Transport Response to Section 92 Further Request Bayswater Marina

PREPARED FOR BAYSWATER MARINA HOLDINGS LIMITED | AUGUST 2021

Following submission of the resource consent application (BUN60373319 dated 15 April 2021) by Bayswater Marina Holdings Limited (“**BMHL**”) for the above development, Auckland Council has issued an additional request for further information under Section 92 of the Resource Management Act 1991 (“**further s92 request**”).

UPDATED APARTMENT BASEMENT TRACKING ASSESSMENT
 SHEET 4 OF 6

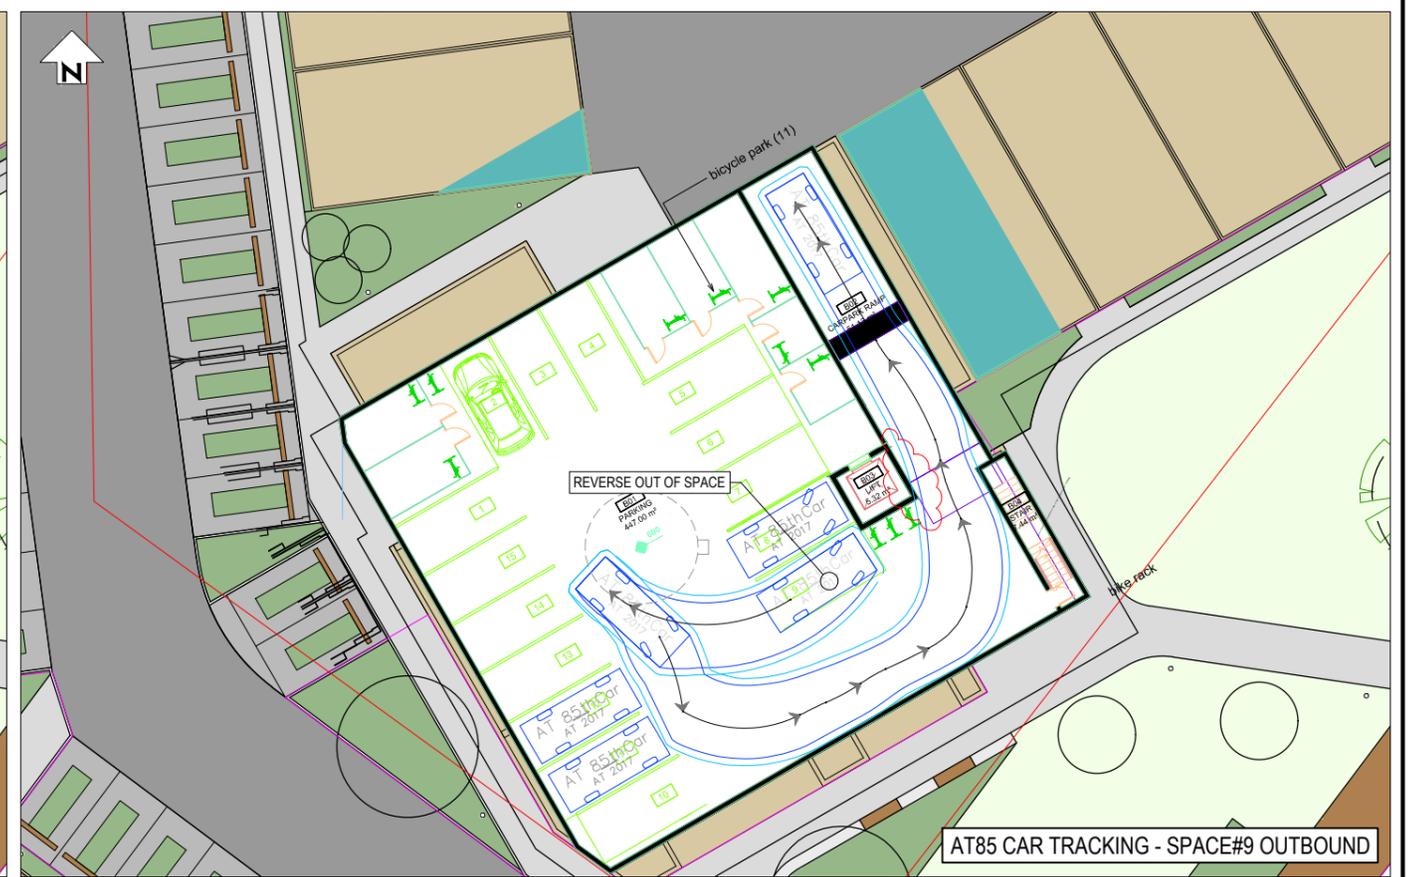
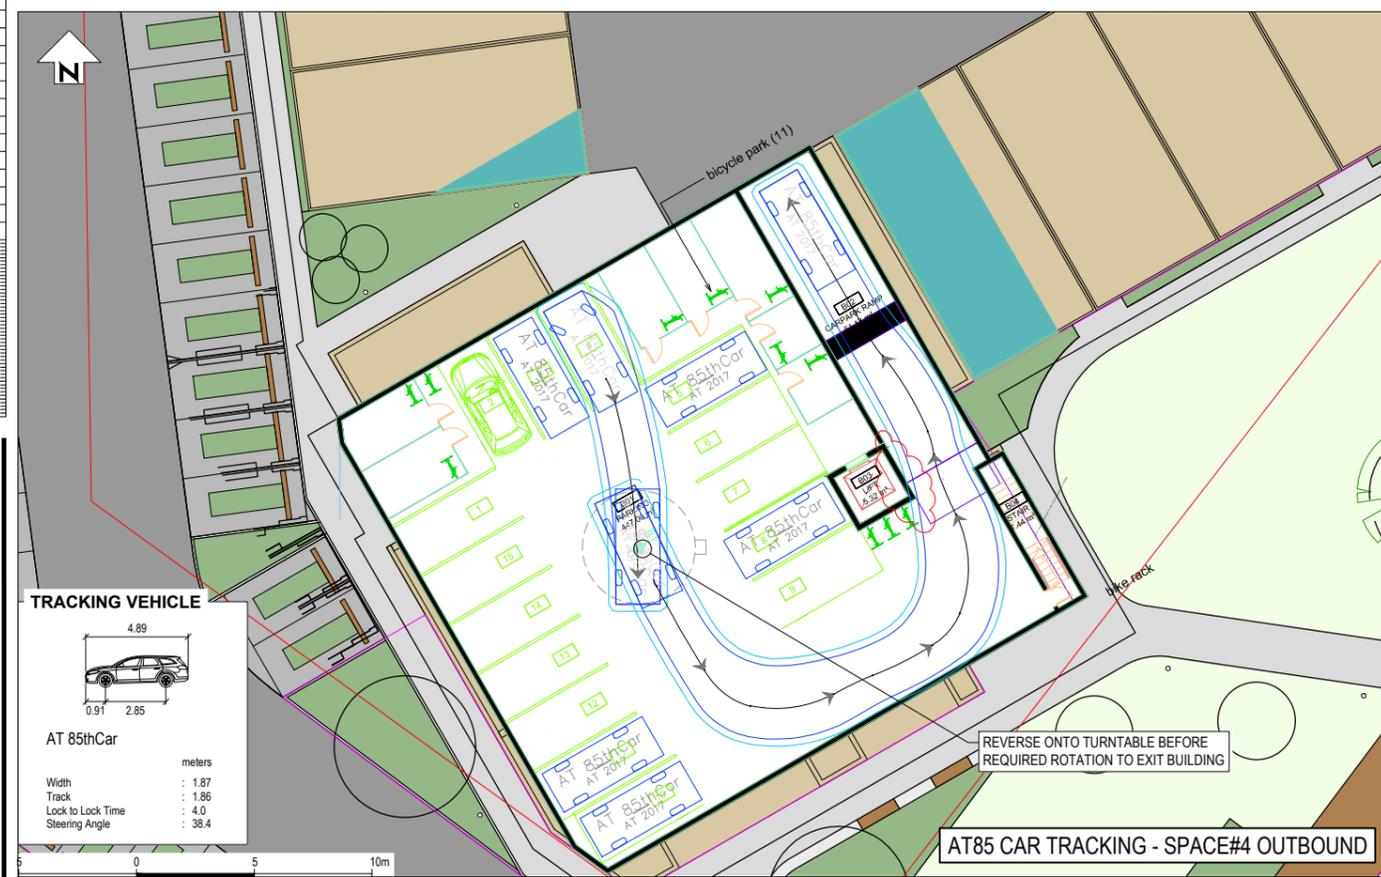
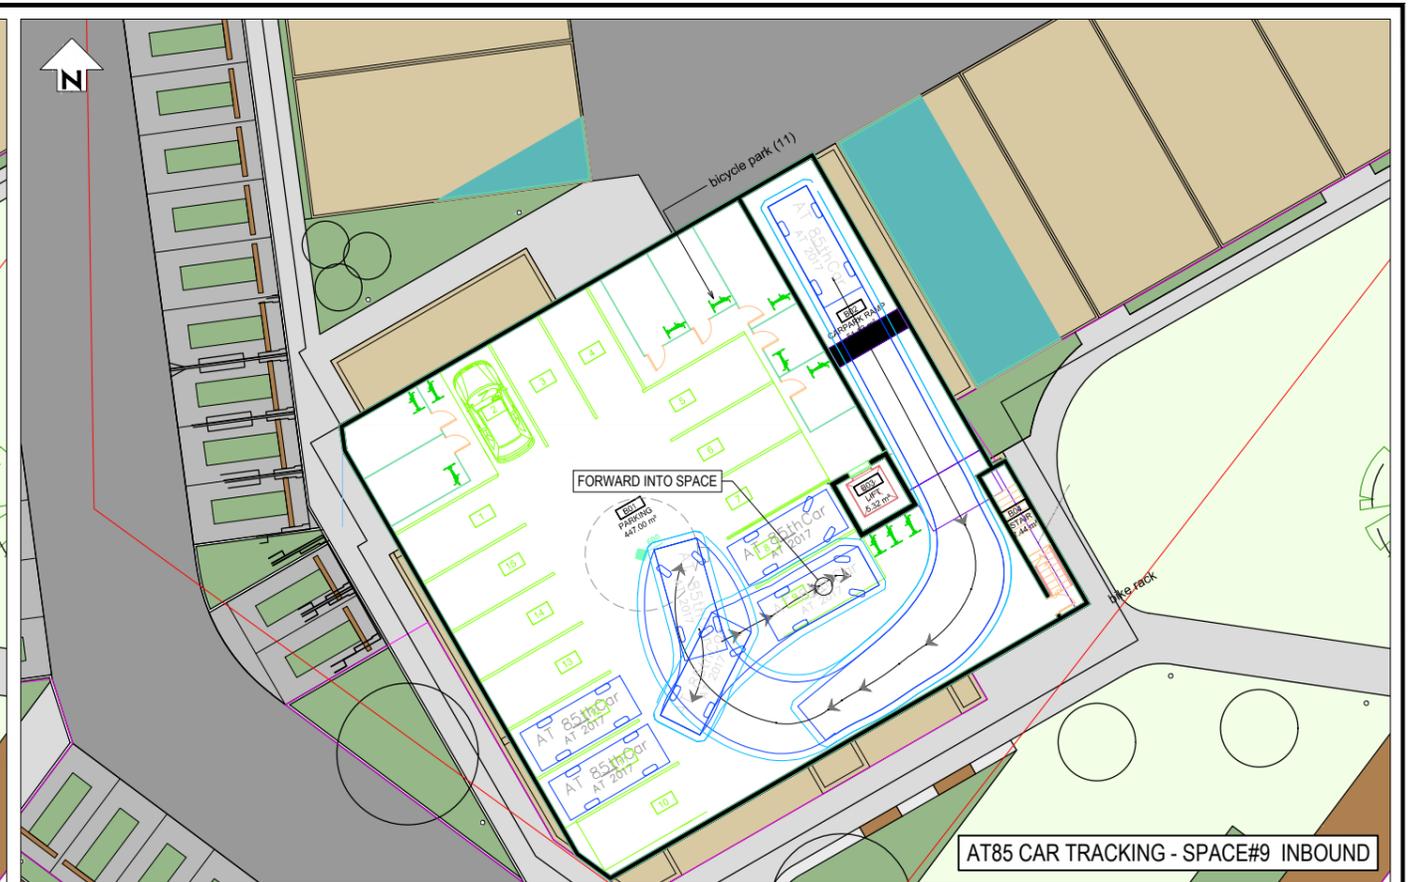
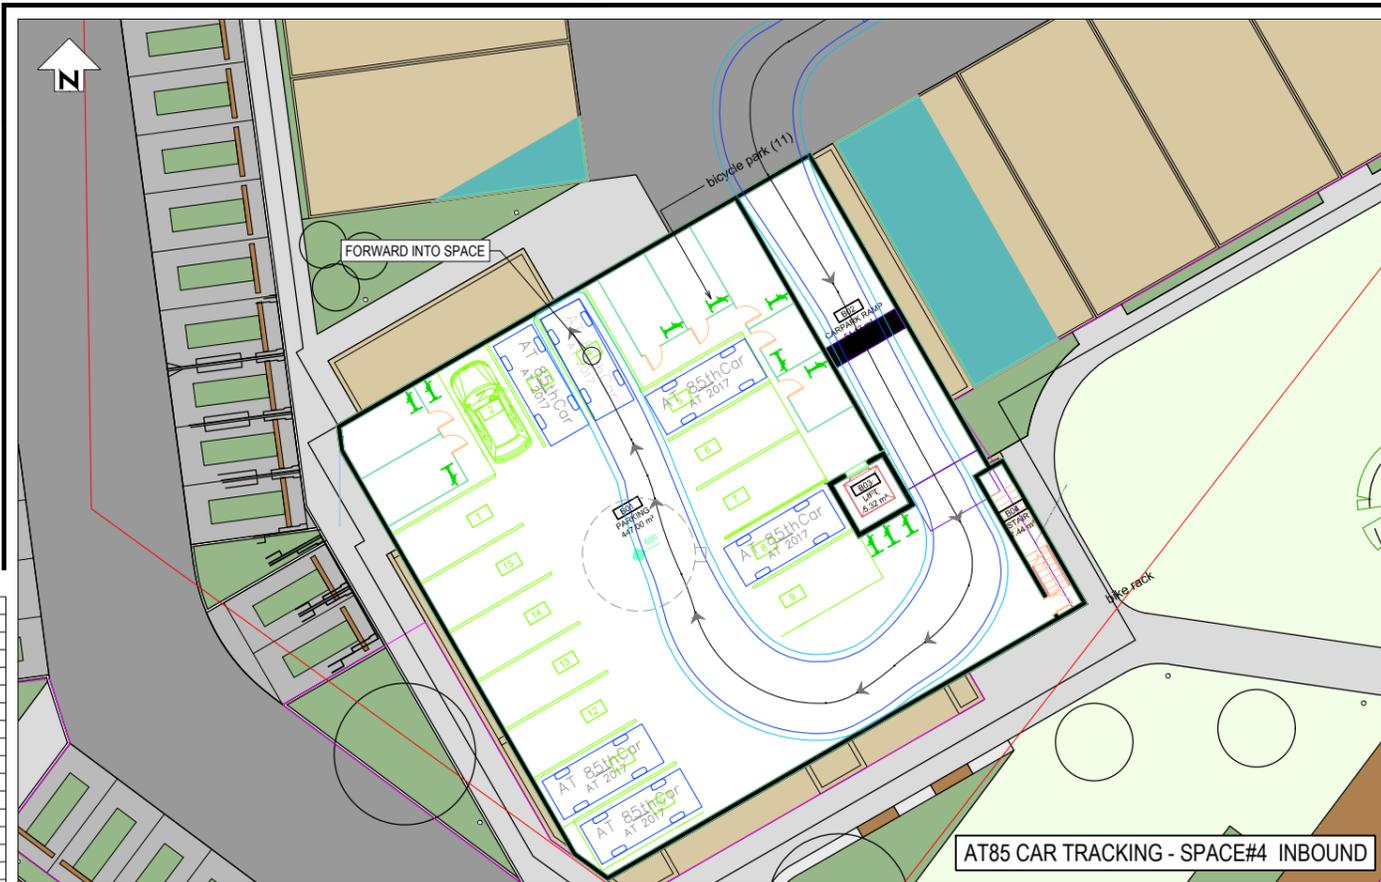
- i. *The Long section for the north apartment ramp provided on Drawing 320 does not appear correct, with the basement ramp not starting from the ground level. Please clarify or correct.*
- ii. *Stantec's response indicates that the access ramps for the apartment buildings are 3.4m wide, however the drawings for the Central Apartment building shows a 3.1m wide access ramp. This is considered too narrow for a ramp with walls on either side of the ramp. Please widen this ramp to a minimum of 3.4m.*
- iii. *The entry to the Northern Apartment building appears to be at a challenging angle. Please provide vehicle tracking showing an 85th percentile vehicle entering and exiting the access. The tracking should include a vehicle entering from the direction of the one-way system in the residential precinct."*

- ii. Sheet 4 of 6 in Appendix B provides a tracking assessment for this narrow section of the vehicle ramp. The assessment shows that the 3.1m ramp can be accessed sufficiently, however, the outbound movement will have limited vehicle clearances (indicated in the red clouds). It is recommended that subtle design changes can be made during the subsequent detailed design stage to accommodate this outbound movement in a safe and effective manner to address the Council/AT concerns.
